Planning Application

Project			
The Chocolate Factory			
Wood Green			
Drawing Title			
Site Plan			
Ground Floor			
Date	Scale	Drawn by	Check by
09/07/17	1 : 500 @ A1	RA	MK
Project No	Drawing No	Revision	
25021	PL010	B

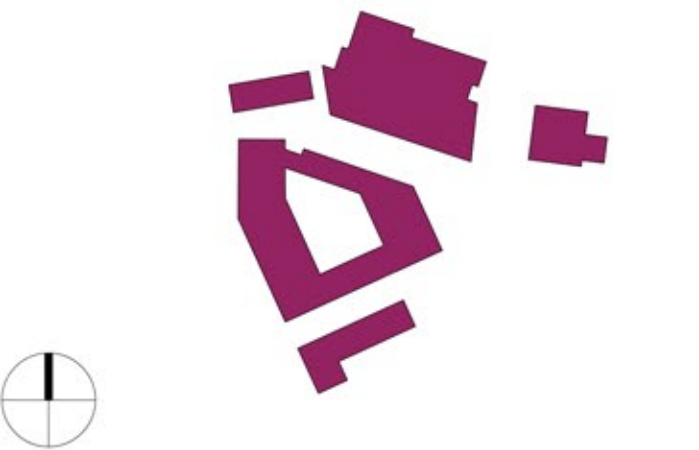
The scaling of this drawing cannot be assured				
Revision	Date	Drn	Ckd	
A	1. Block B: Removal of the tail end, free standing brick wall proposed to the south to enable future development to connect to and demonstrating that 2no storey on the south elevation can act as 'flank wall' (no residential accommodation, services access required only).	26.01.18	MK	MK

2. Block E: storey of residential units added along Western Road, Core 1 removed, commercial space increased (2 floors), duplex units along Western Road revised to open plan kitchen/ living/ dining

3. Block D: commercial proposed to the ground floor and extension of the building footprint to take in the site area, two floors of residential added to the corner, 2 storey 'flank wall' proposed to south to enable future development to connect to.

4. Block F: storey height reduced to 4050mm			
	5. Landscape: short stay cycle stand location amended, gate/ barrier to north of The Chocolate Factory added			
B	Revisions to heights of Block B, D and E	16.02.18	CG	PJ
